Re: [EXTERNAL] Concerns about Voigt Park HDC Application

I have some additional comments on [HDC Application 2025-00576](#) for Voigt Park. I would request that if the Historic District Commission decides to approve this application, that it only does so **with the following conditions:**

I am writing in regards to [HDC Application 2025-00576](#) to be considered at the [October 8, 2025 Historic District Commission meeting](#).

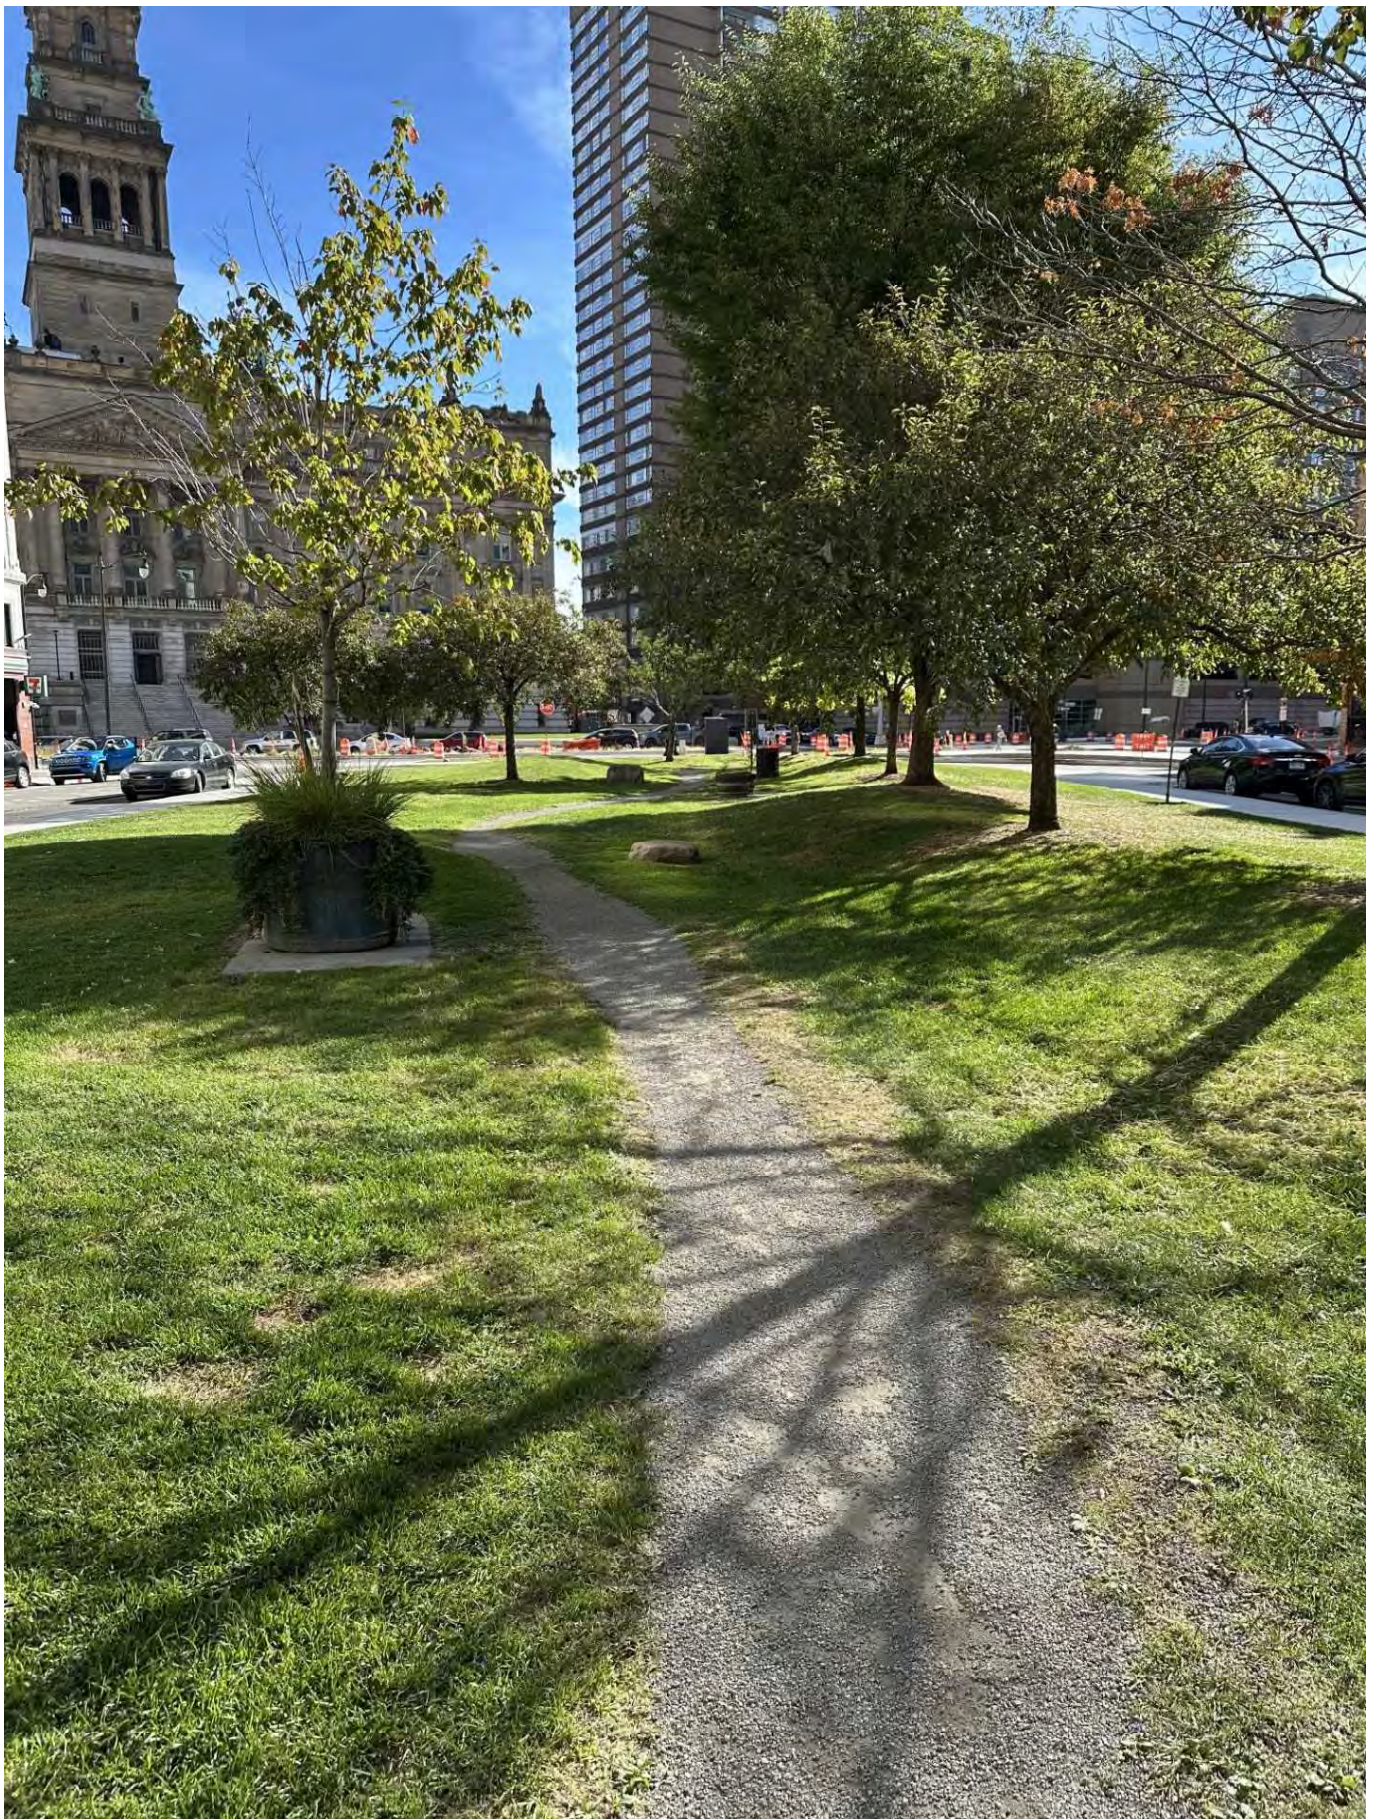
Regarding alternative path materials used in Detroit Parks mentioned in my previous comment. Please see photos below from Campus Martius, Cadillac Square and Belle Isle where gravel, and compacted soil are used to create permeable and natural walking paths.
